PROJECT REVIEW COMMITTEE - CITY OF WILDWOOD
PRC Chairperson – Melanie Strickland

Agenda
Regular Meeting
July 14, 2026 10:00 AM
Commission Conference Room 124
100 N Main Street

SUBJECT: **26-0318 SPM - Circle K US 301 & CR 462**

The applicant is seeking approval from the Project Review Committee for modifications to the previously approved plans under the project number SP 2405-001 Circle K US 301 & CR 462. The modifications consist of a natural gas connection, relocation of a transformer, revision to the landscape plan, and changes to the stormwater system based on as-built information, on 3.28 acres MOL.

SHEET NUMBER C3.0

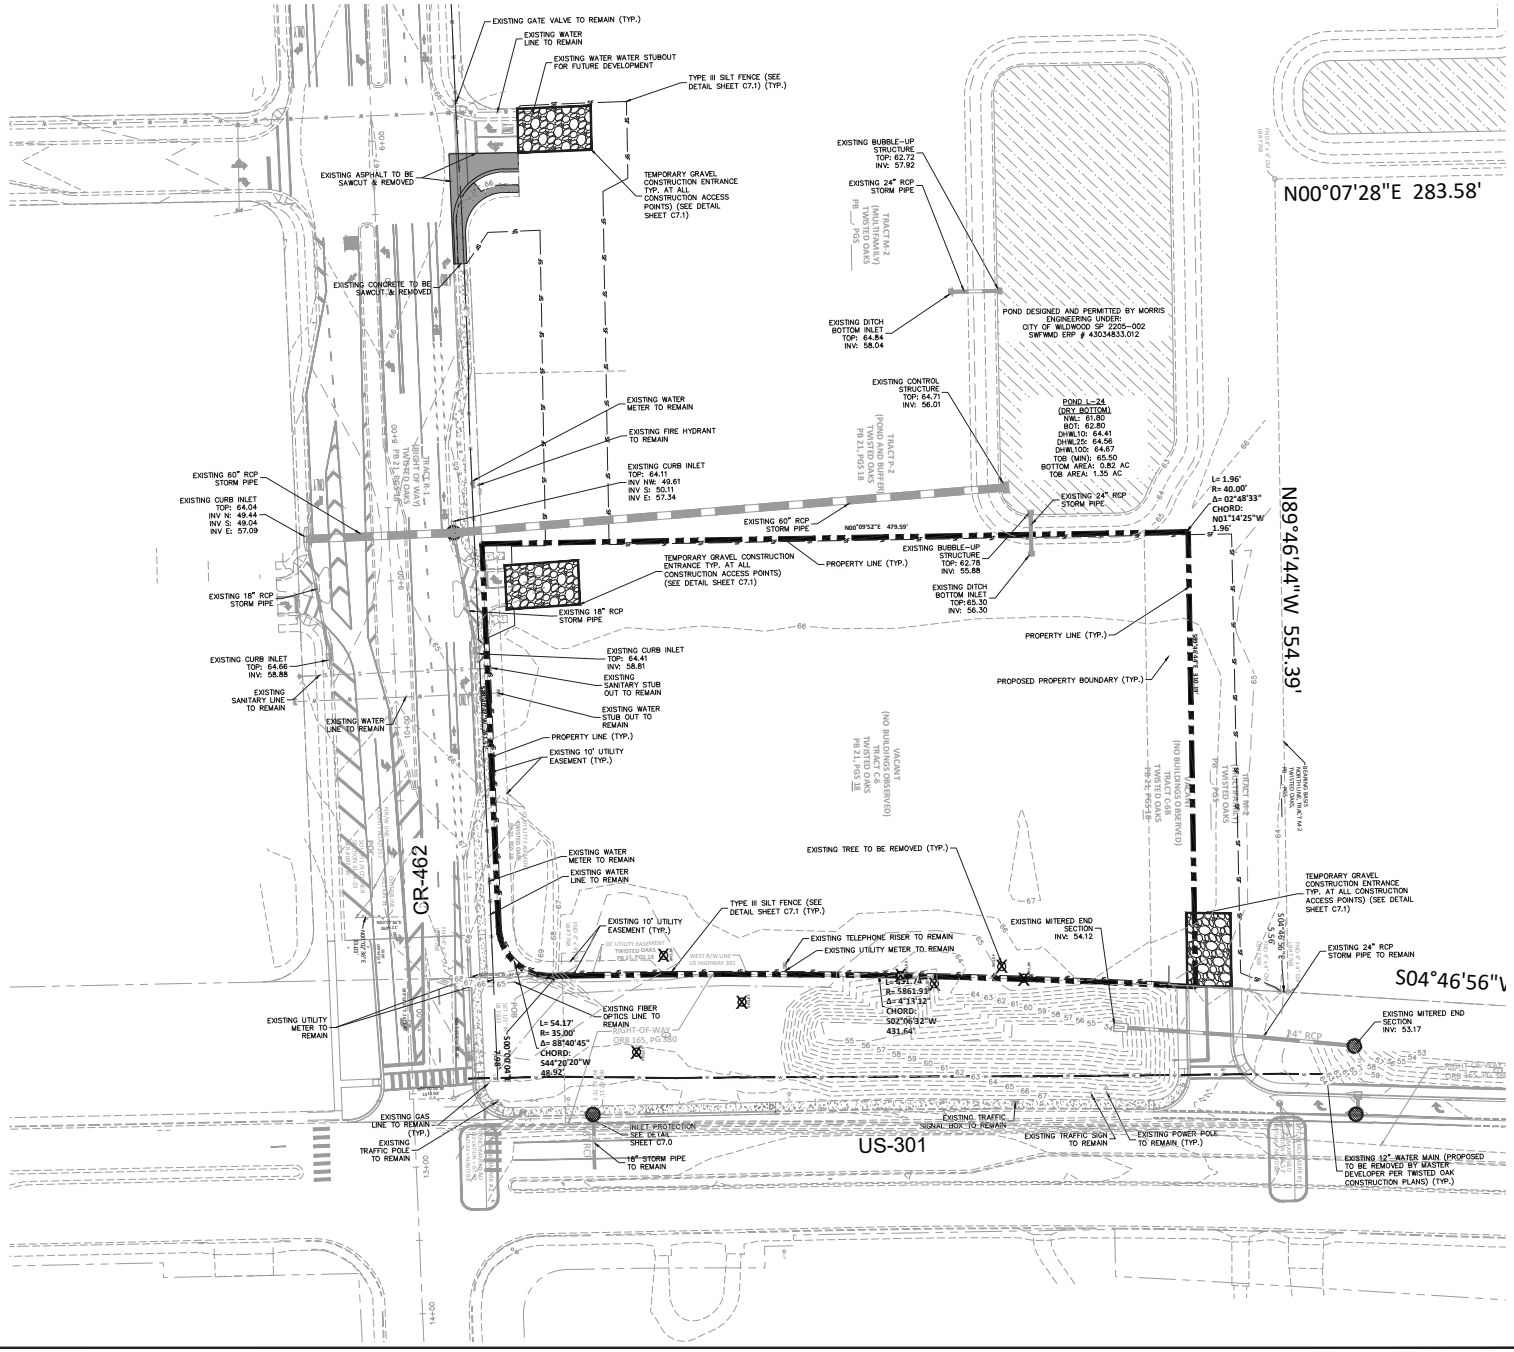
Sheet C3.0 – Existing Conditions & Demolition Plan

SHEET NUMBER
C4.0

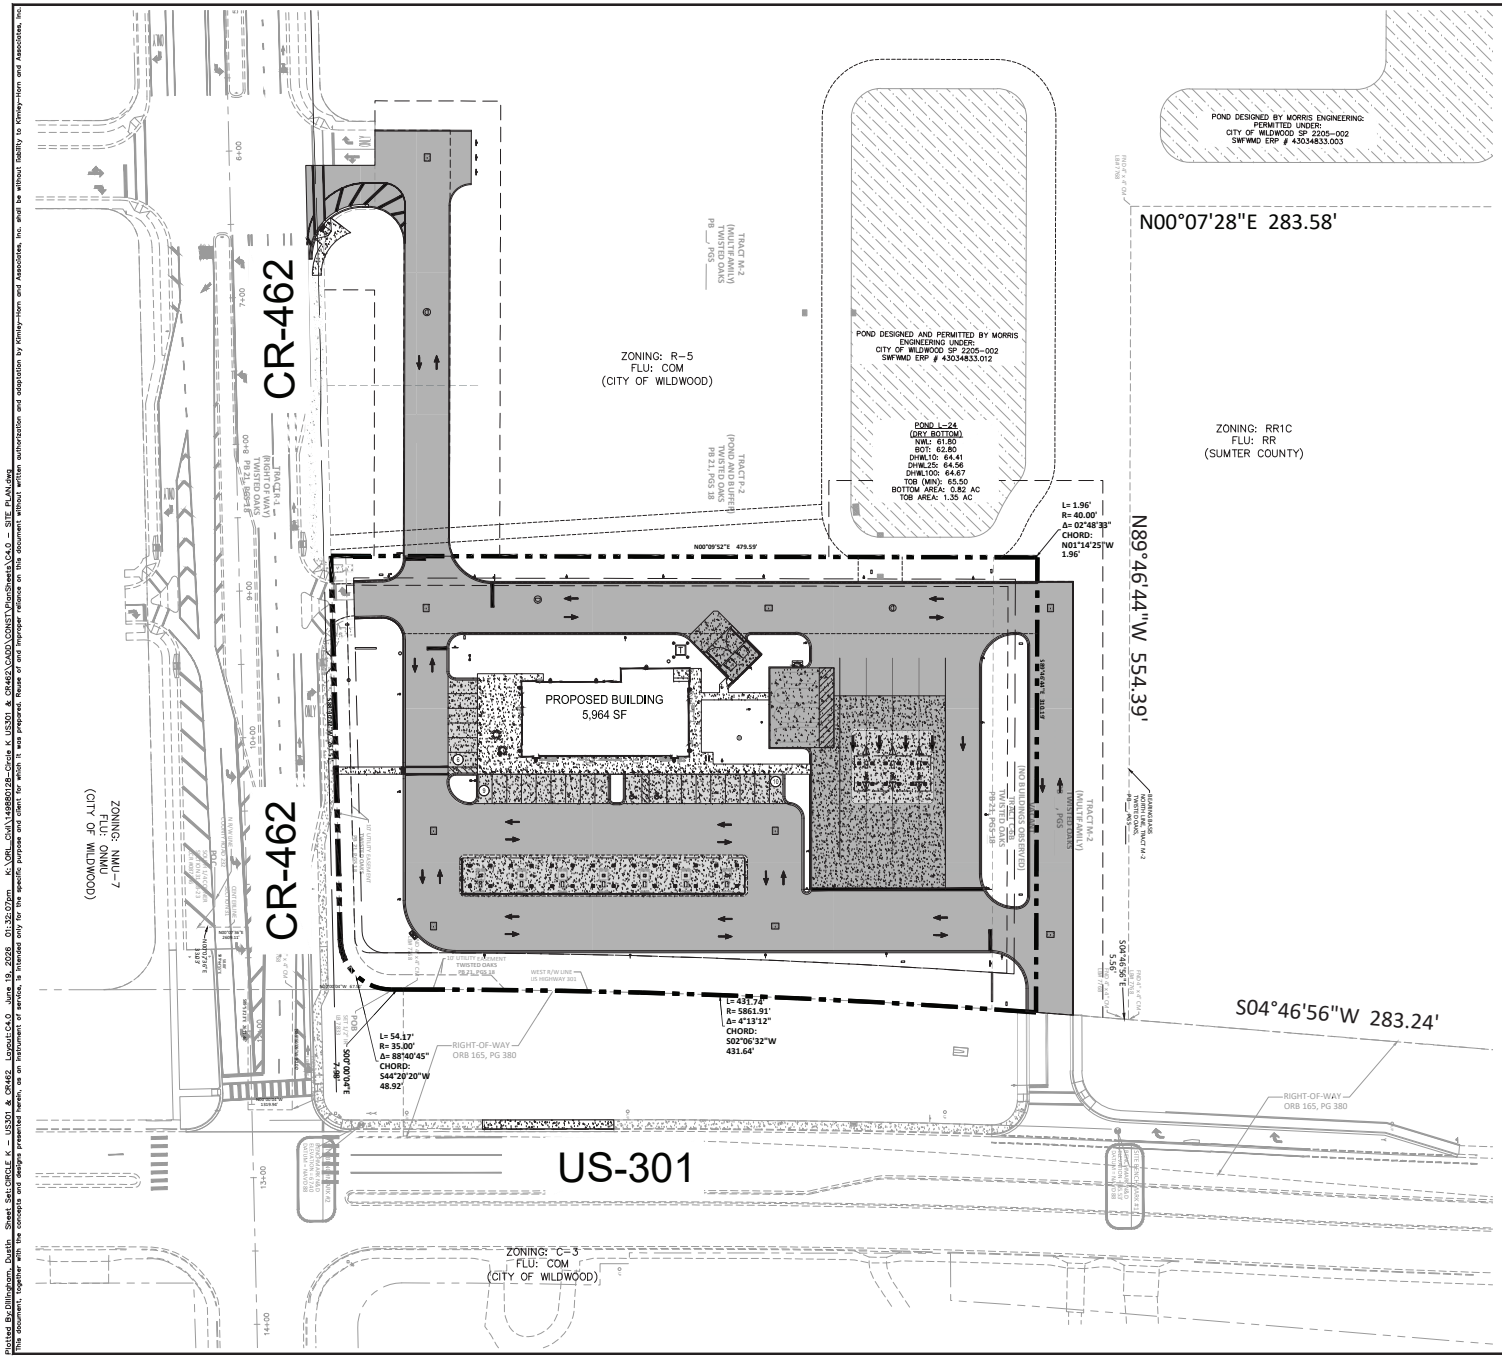
Sheet C4.0 – Overall Site Plan

SHEET NUMBER C4.1

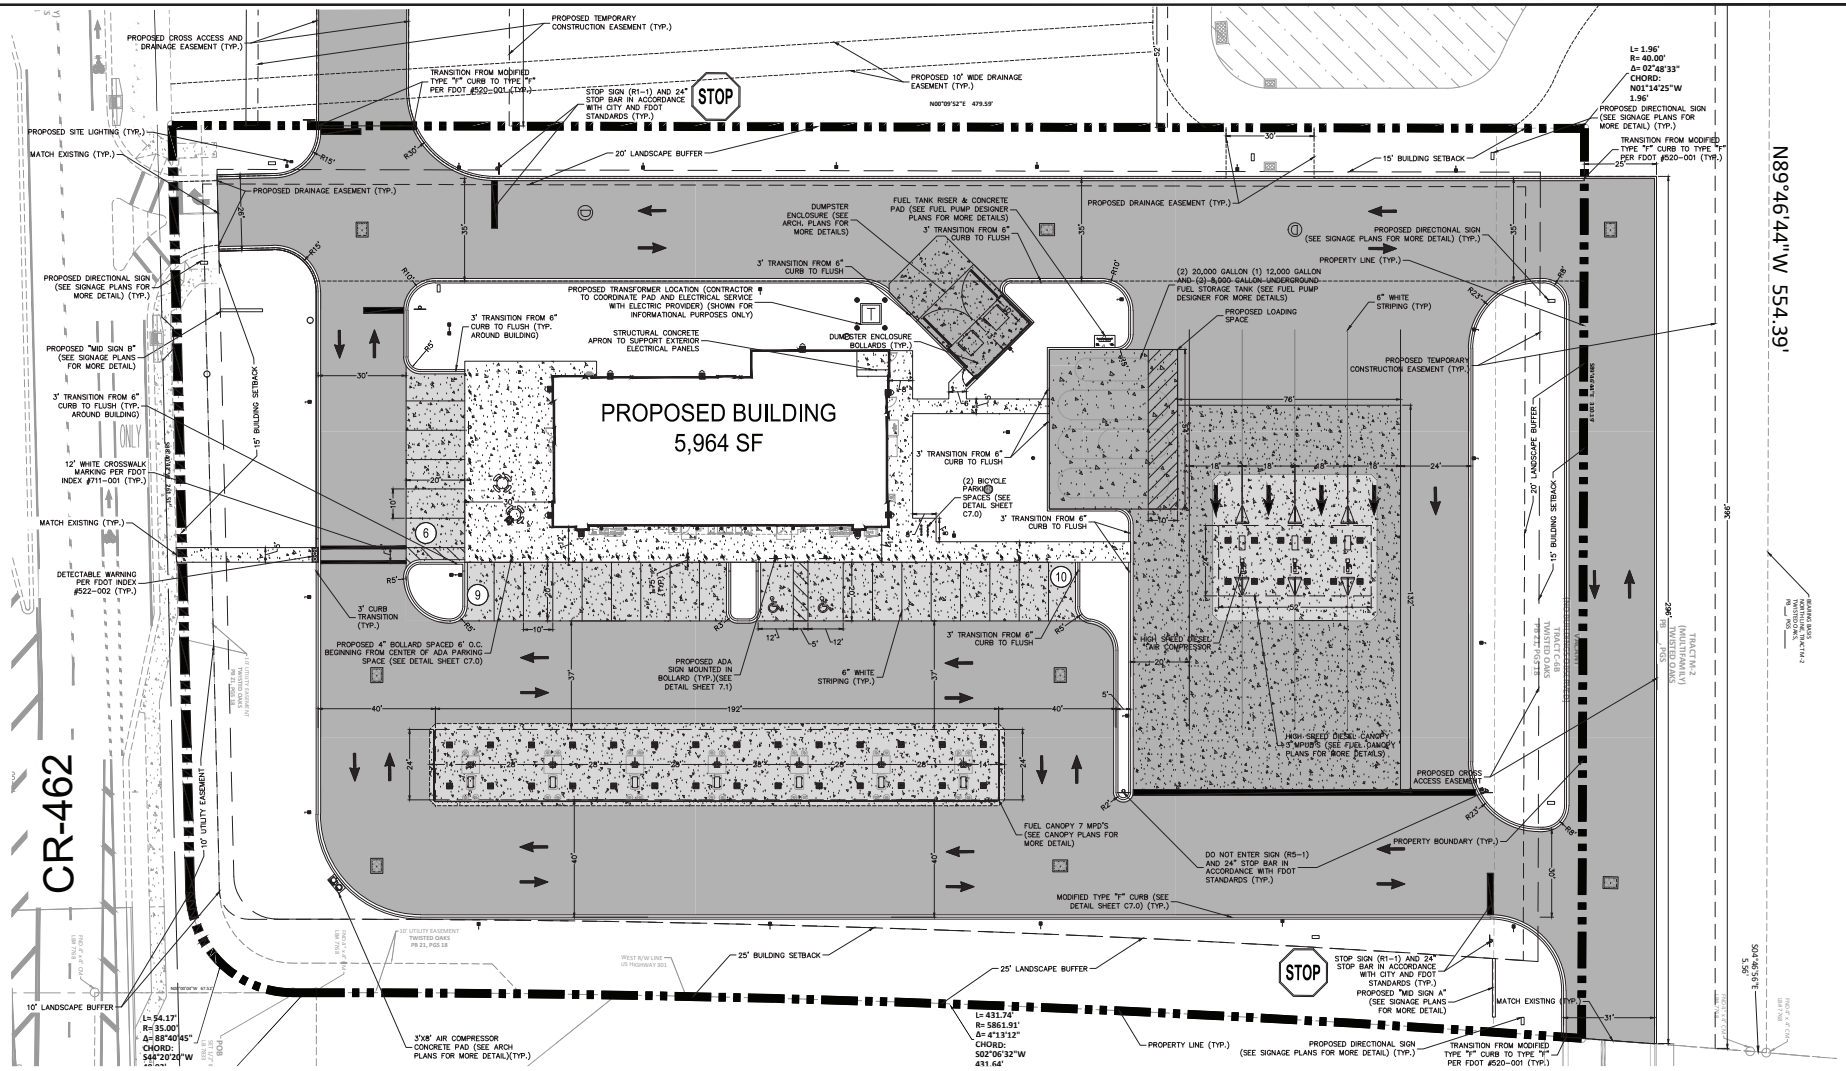
a) Updated to show modified F curb on site and additional heavy-duty concrete in HSD area per Circle K bid set comments.
b) The proposed transformer was relocated per the electrical provider's request.

SHEET NUMBER
C4.2

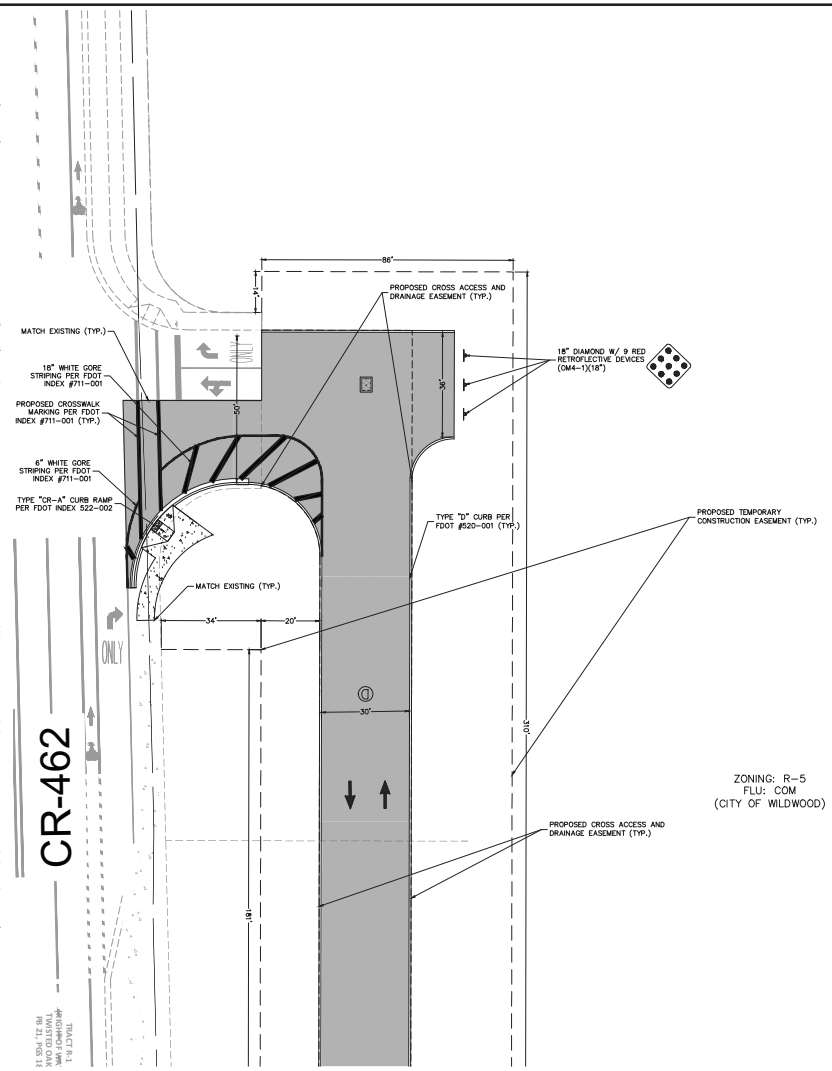
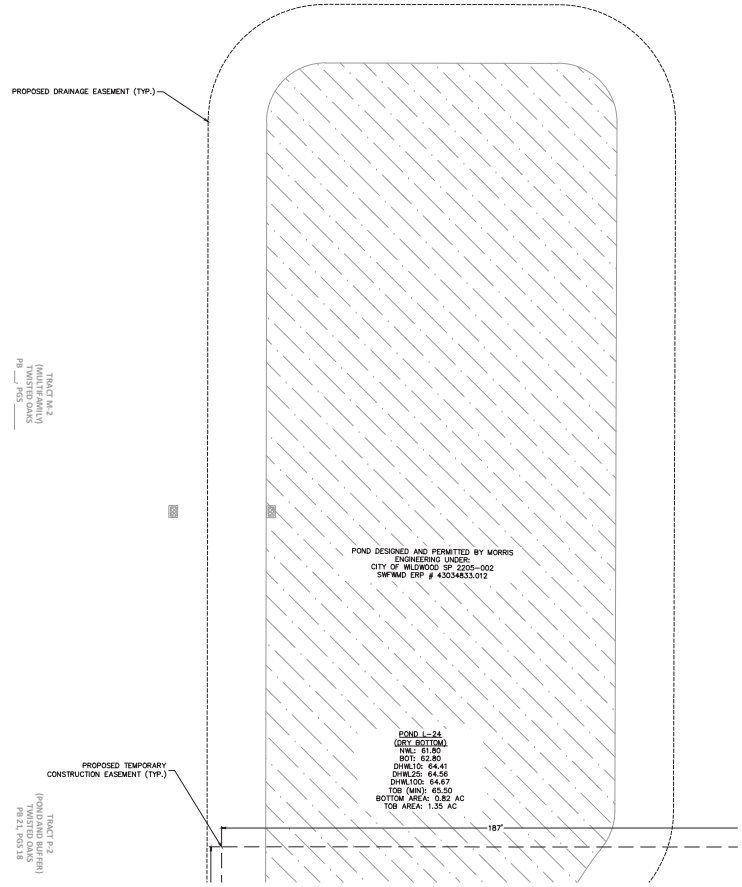
Sheet C4.2 – Site Plan

SHEET NUMBER C5.0

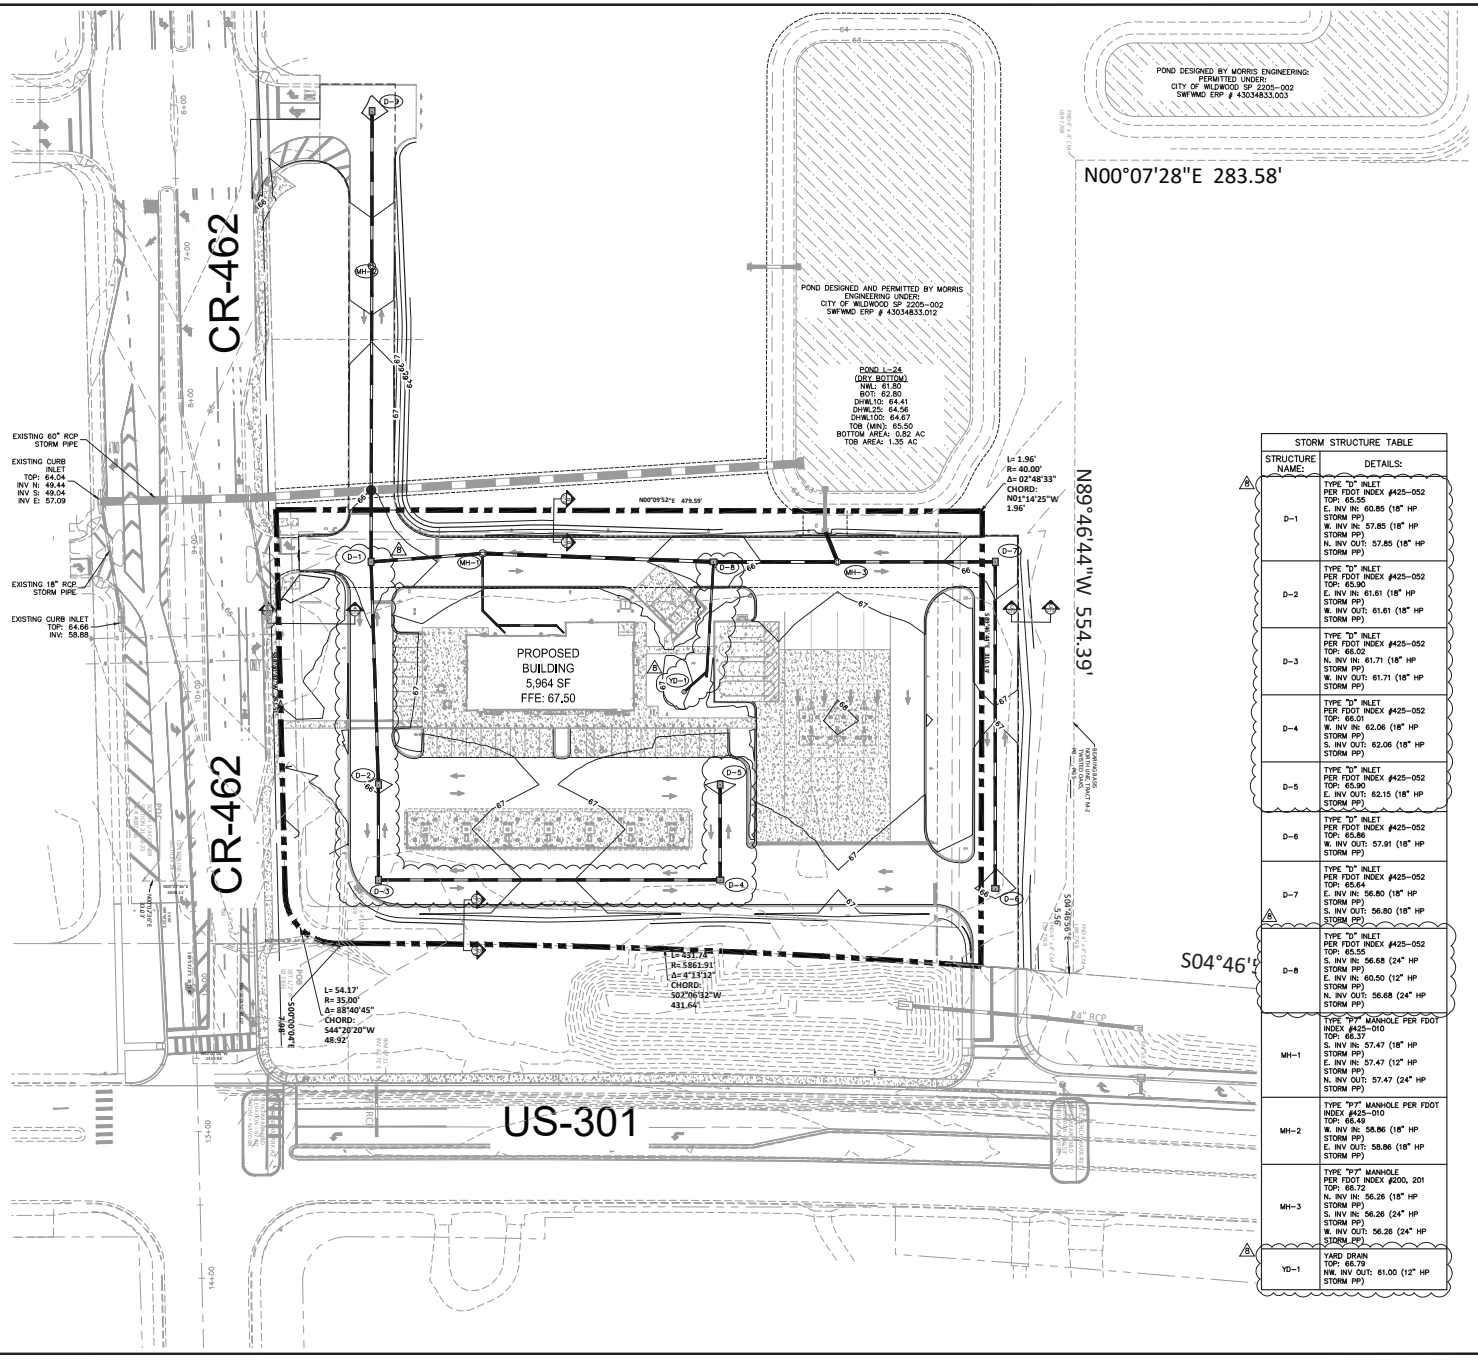
a) The proposed grading at the points of connection and stormwater design were revised to accommodate the master infrastructure as-built information.
